**HORIZONTAL DIRECTIONAL DRILL ANALYSIS  
EAGLEVIEW BOULEVARD CROSSING  
PADEP SECTION 105 PERMIT NO.: E15-862  
PA-CH-0138.0000-RD  
(SPLP HDD No. S3-0331)**

**EAGLEVIEW BOULEVARD CROSSING**  
**PADEP SECTION 105 PERMIT NO. E15-862**  
**PA-CH-0138.0000-RD**  
**(SPLP HDD No. S3-0331)**

### **HORIZONTAL DIRECTIONAL DRILL REDESIGN**

#### **Revised Horizontal Directional Drill Design Summary: 20-inch**

Figure 1. Original 20-Inch HDD Plan and Profile

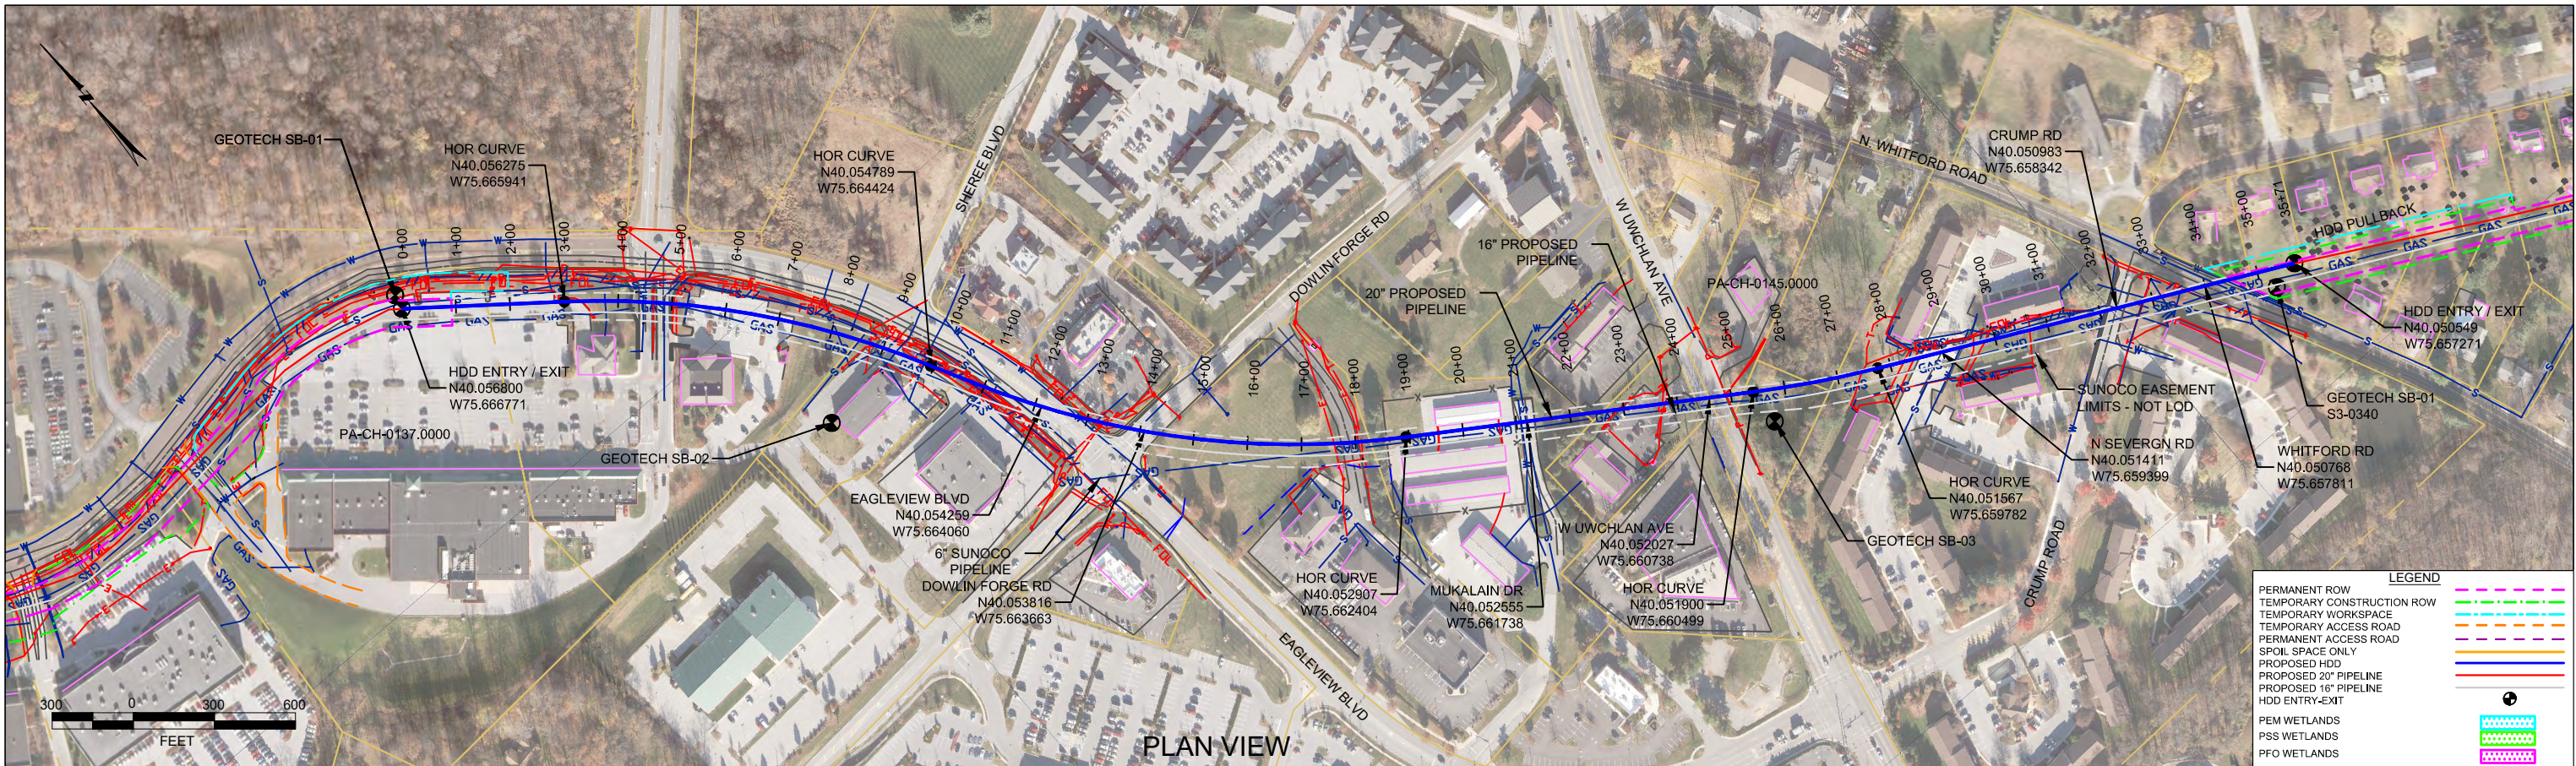
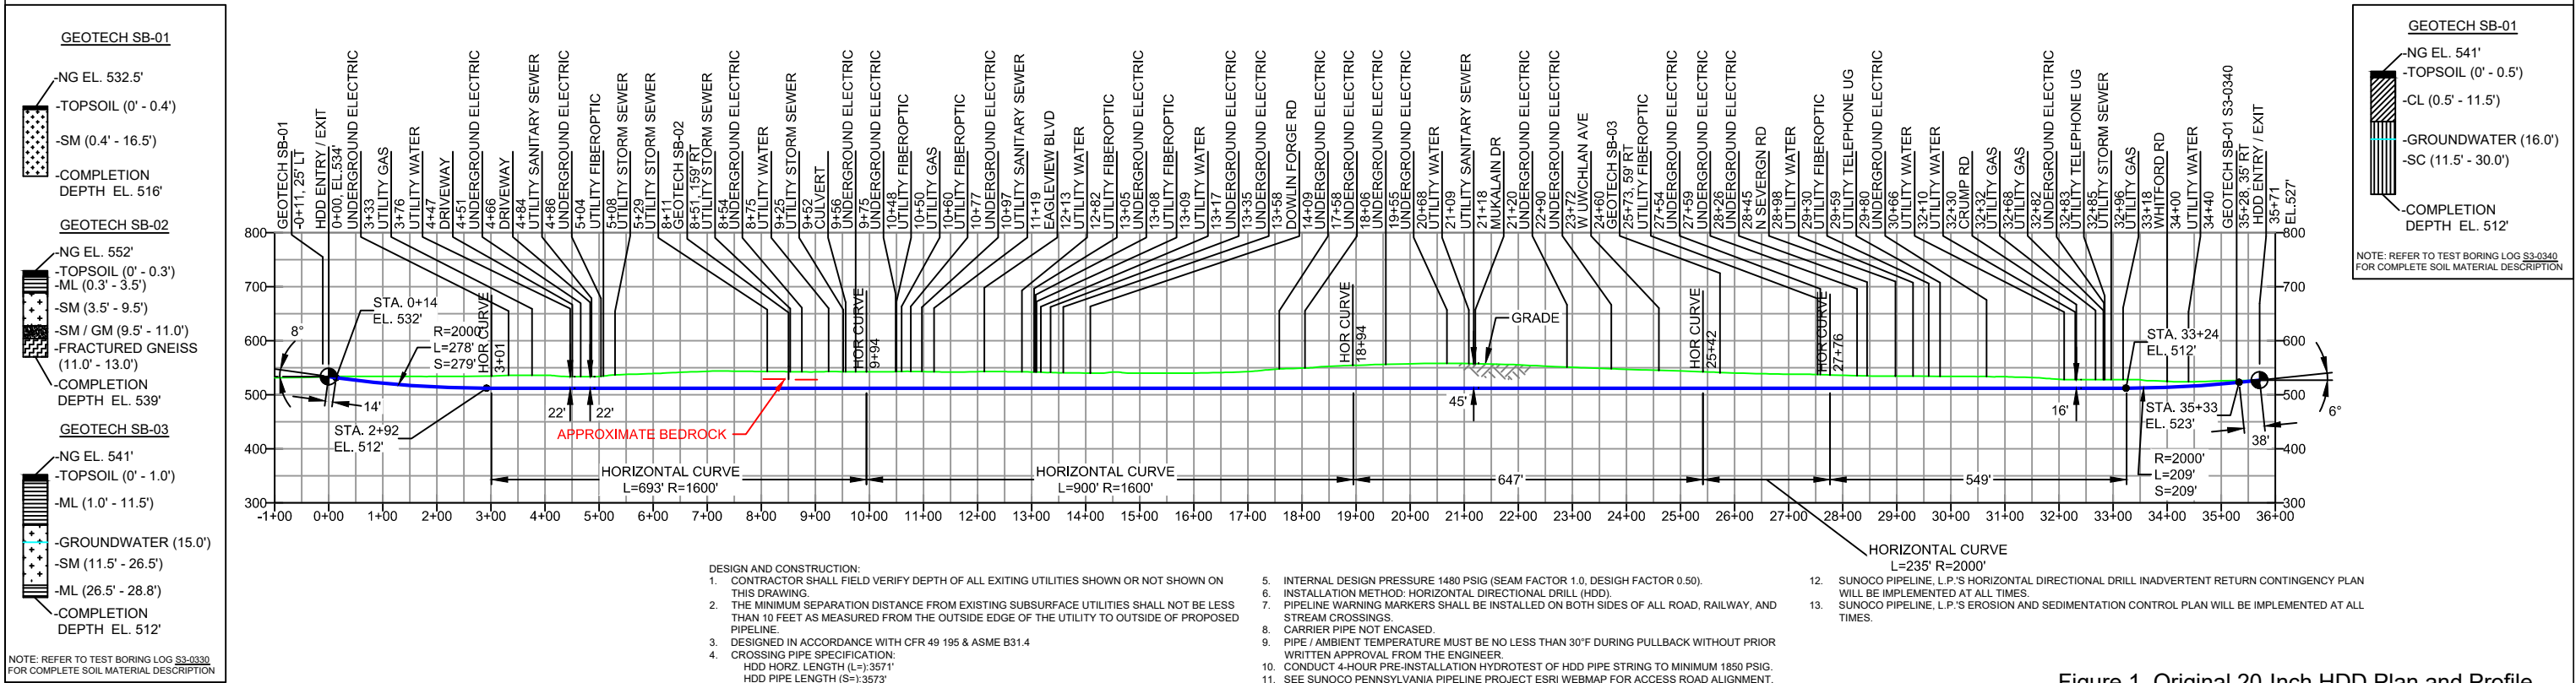
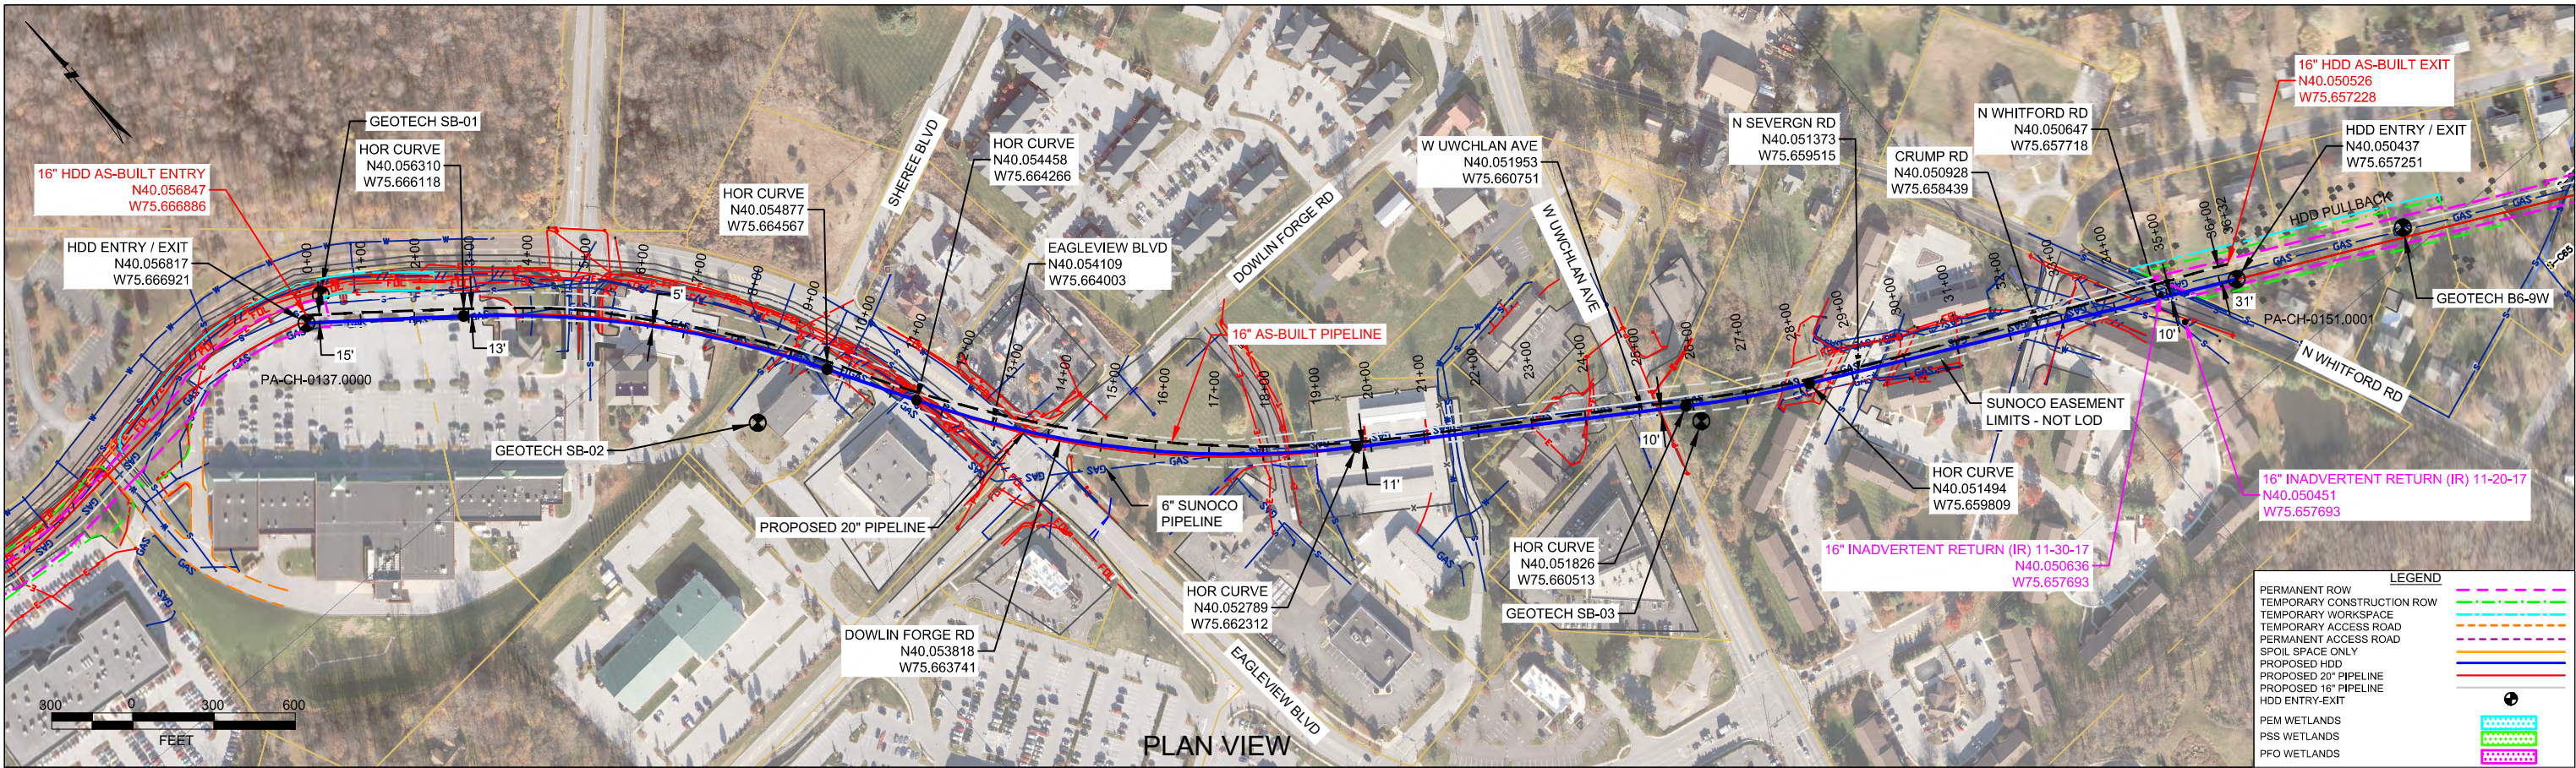
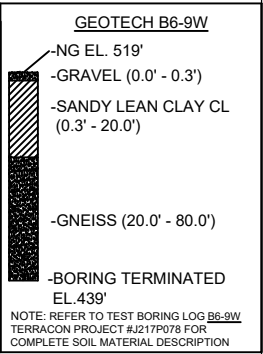
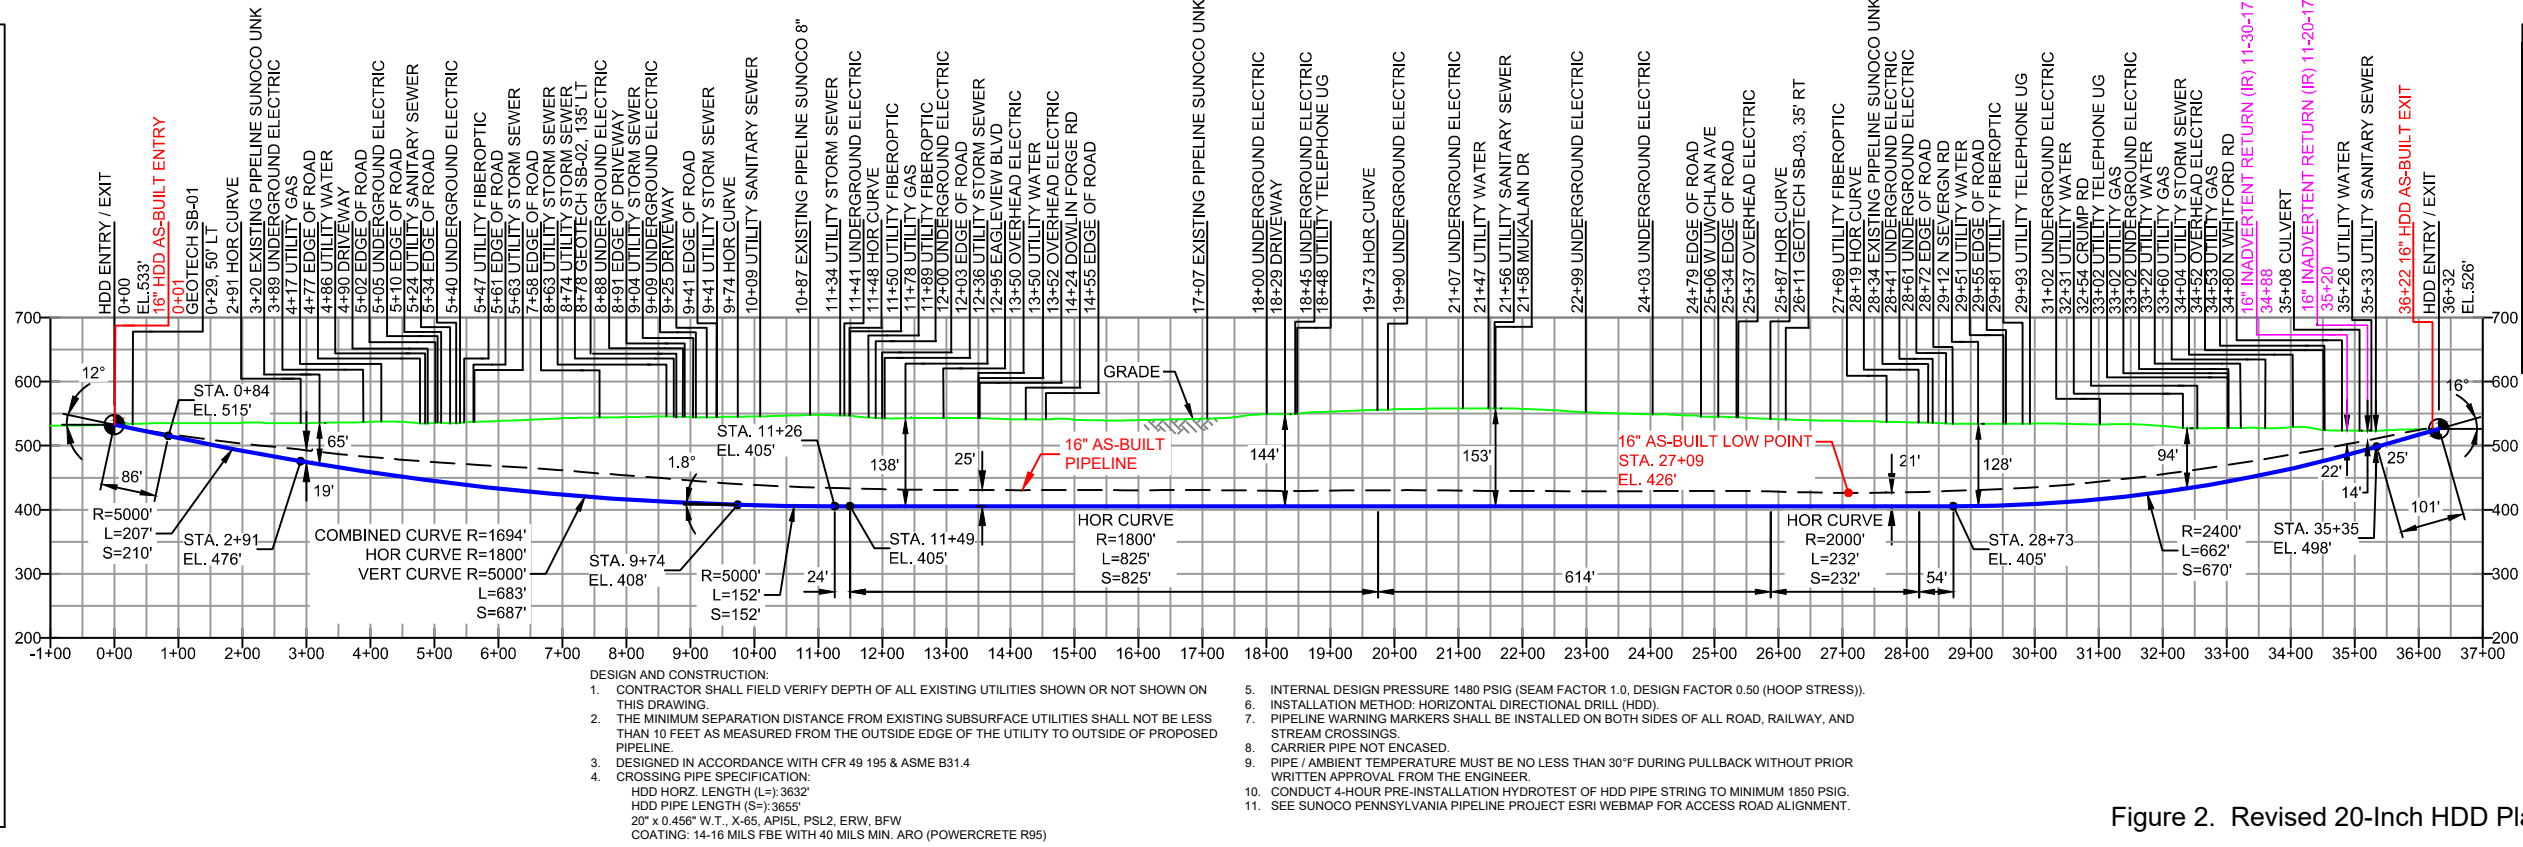
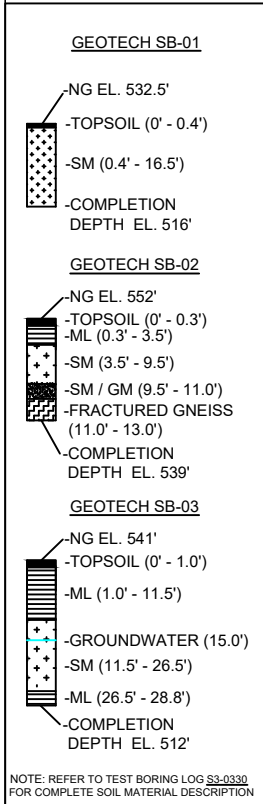
SPLP has considered all geologic data, and the IR events during drilling of the 16-inch pipeline, and has redesigned the 20-inch HDD profile accordingly. A summary of the redesign factors is provided below. The original and redesigned HDD plan and profile for the 20-inch pipeline are provided in Attachment 2.

- Horizontal length: 3,632 ft
- Entry/Exit angle: 12-16 degrees
- Maximum Depth of cover: 153 ft
- Pipe design radius: 1,800-5,000 ft

Based on the original and revised profile for the 20-inch HDD, the revised HDD profile increases the depth in bedrock for a majority of the HDD profile; therefore, adjustments to the plan of construction for the 20-inch pipeline represent a reduced risk of IRs. Punch out IRs are common on entry and exit of the drilling tool and other measures are required to minimize this IR potential. In particular, upon the start of this HDD, SPLP will employ the following HDD best management practices:
